REQUEST FOR AMENDMENT, REVISION 1  
SALEM GENERATING STATION  
UNIT NOS. 1 AND 2  
FACILITY OPERATING LICENSE NOS. DPR-70 AND DPR-75  
DOCKET NOS. 50-272 AND 50-311

LCR 88-10

PROPOSED LICENSE CHANGE  
SALEM GENERATING STATION  
UNIT NOS. 1 AND 2  
FACILITY OPERATING LICENSE NOS. DPR-70 AND DPR-75  
DOCKET NOS. 50-272 AND 50-311

FIGURE 1

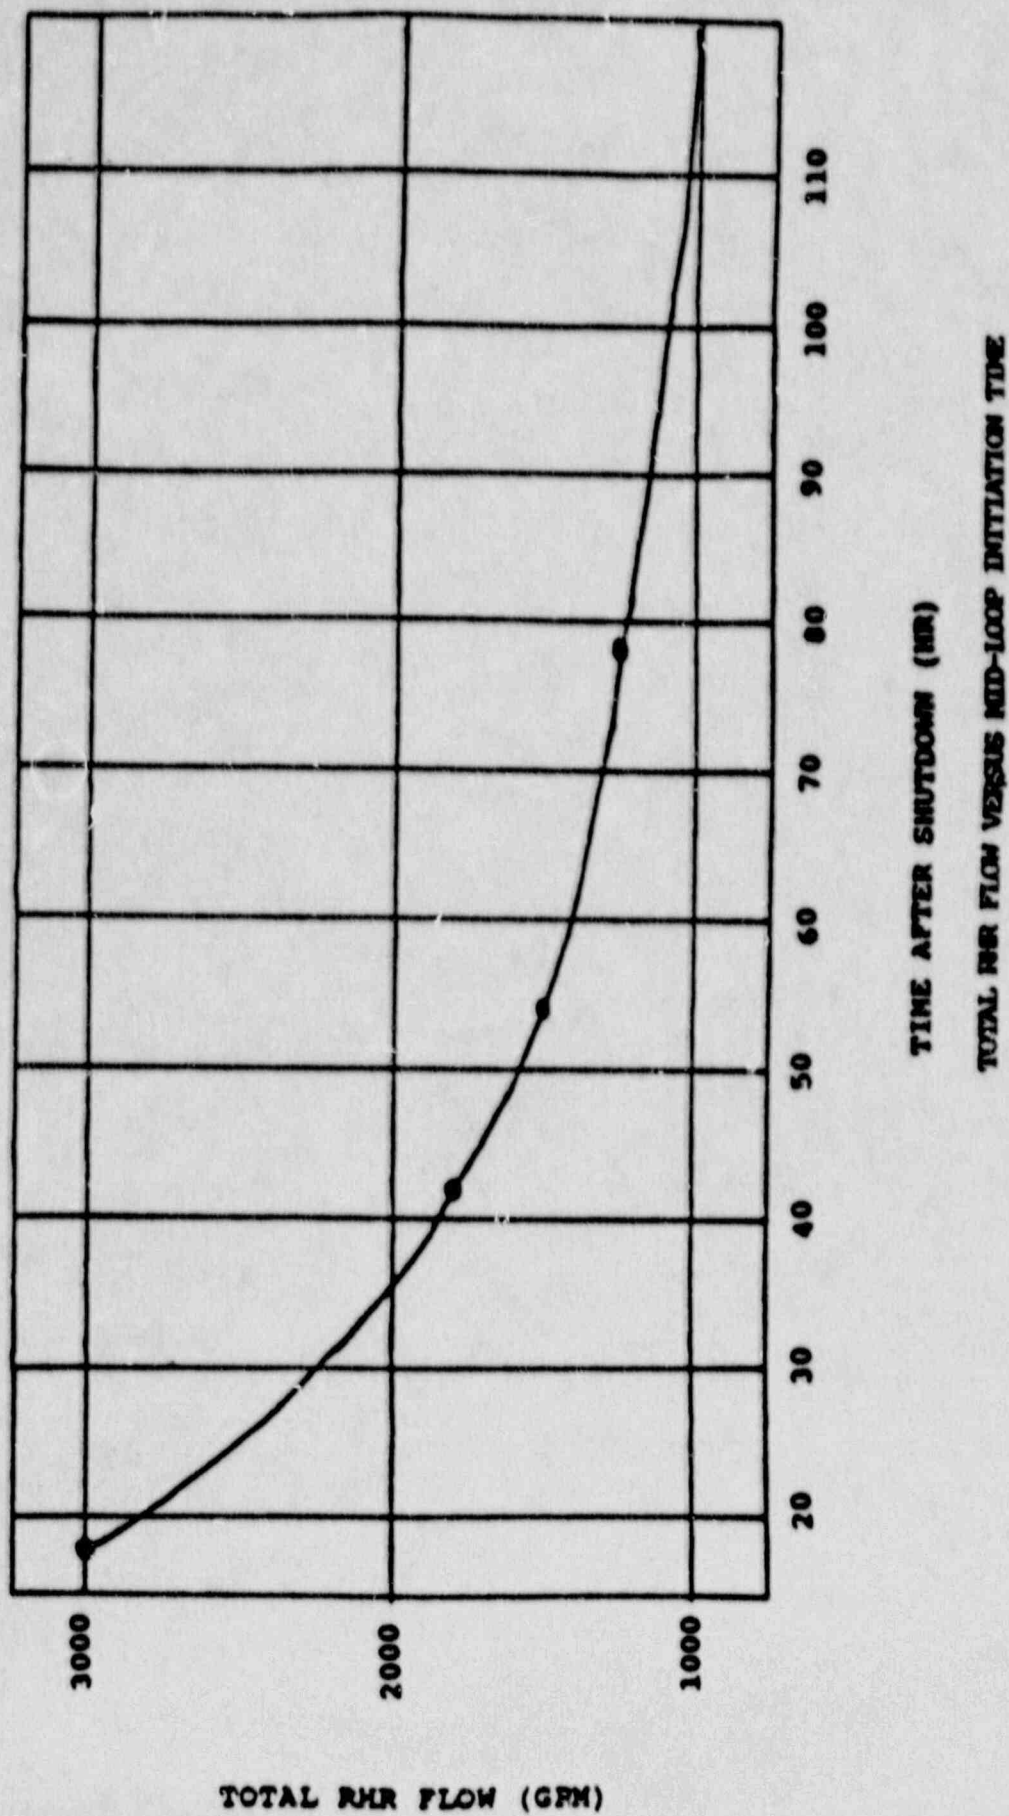
Table 1 (attached) indicates the required RHR flow rate for specified periods of time after shutdown. Mid-loop operation is not implemented at Salem until at least 72 hours after shutdown (by procedure). Adequate decay heat removal can be accomplished with <1500 gpm RHR flow at this time. The required flow rate decreases further with increased time after shutdown. This is graphically depicted in Figure 1 (attached).

FIGURE 2

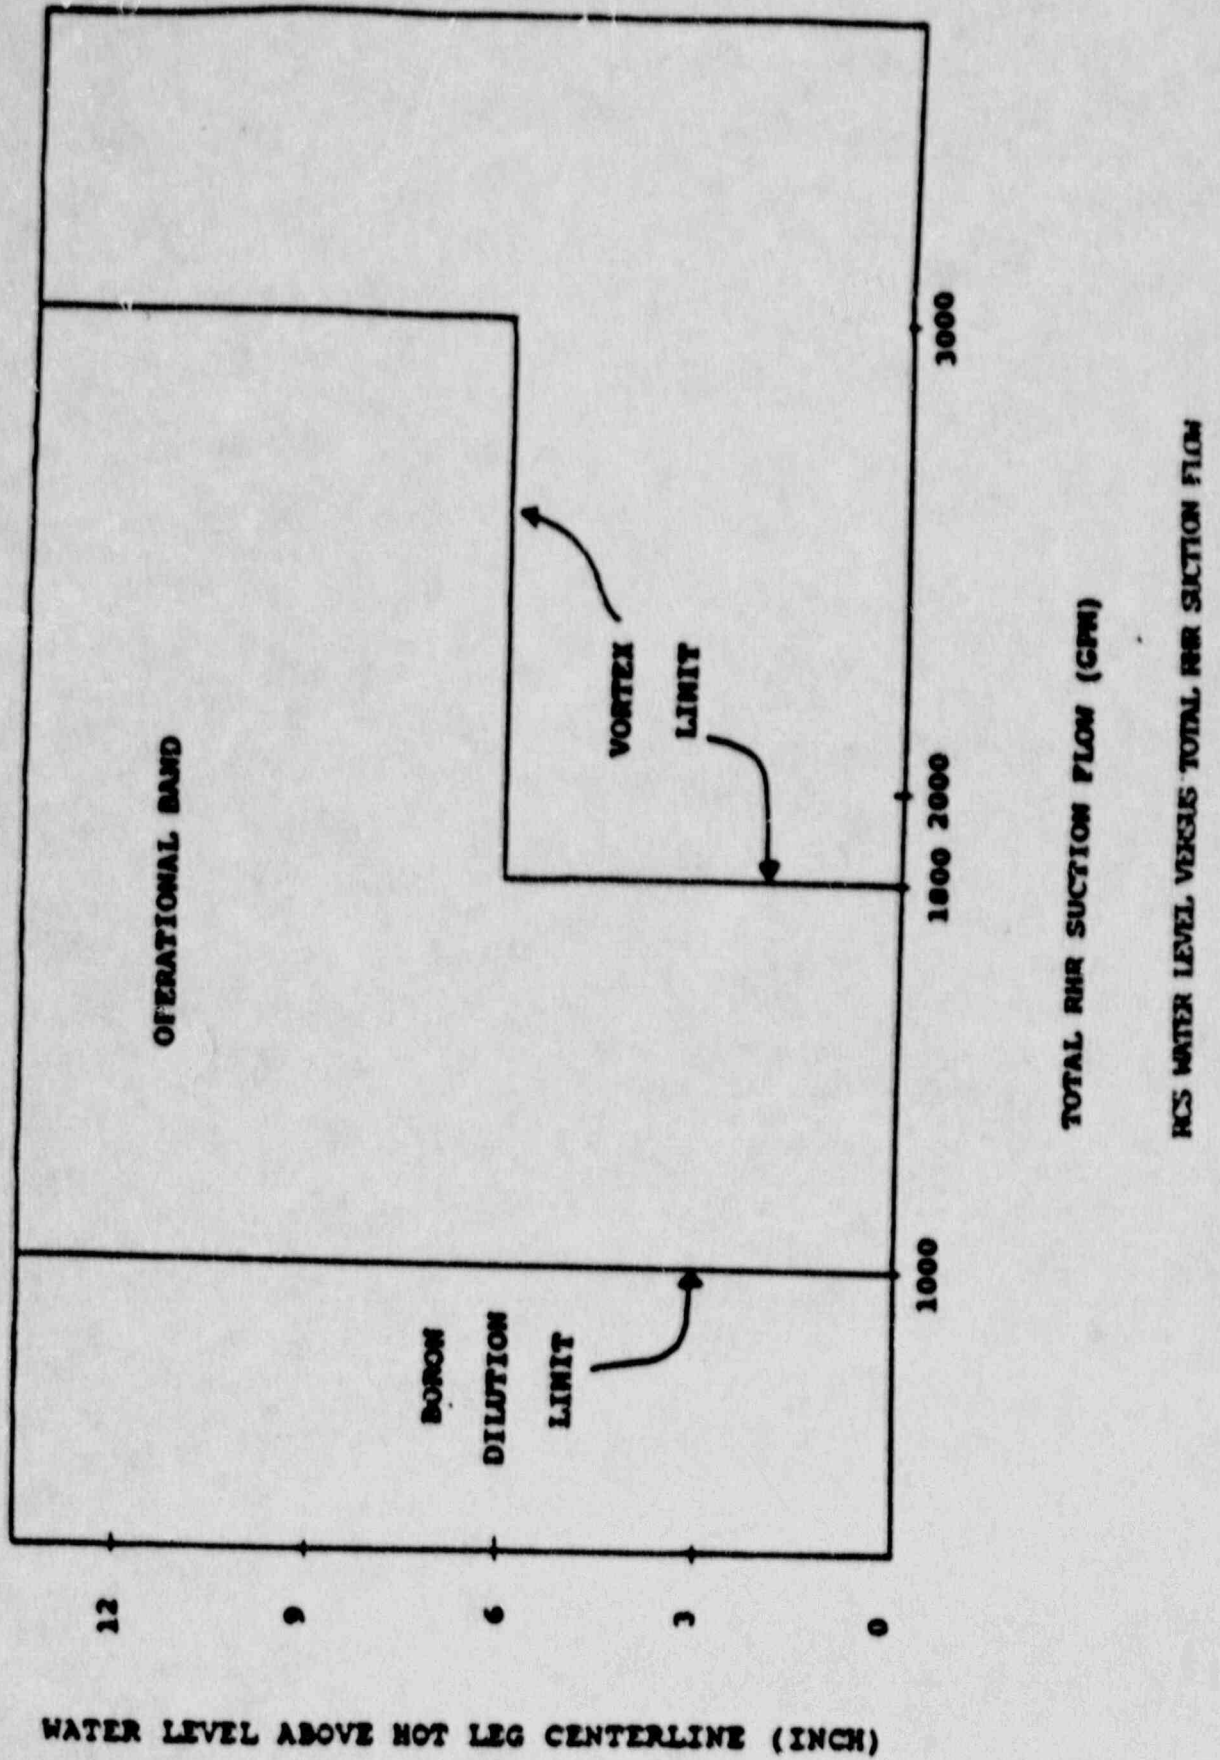
Figure 2 (attached) depicts limitations on RHR flow rate for various RCS hot leg water levels. The data reveals that RHR flow rates should be maintained between 1000 and 1800 gpm when RCS hot leg water level is < 6 inches above centerline. RHR flow rates can be extended from a maximum of 1800 gpm to 3000 gpm, when RCS hot leg water level is > 6 inches above centerline. Figures 1 and 2 show that required RHR flow rates vary based on RCS water level and the time after shutdown. More importantly, the present Technical Specification minimum flow rate (3000 gpm) exceeds the maximum flow rate specified for vortexing concerns.
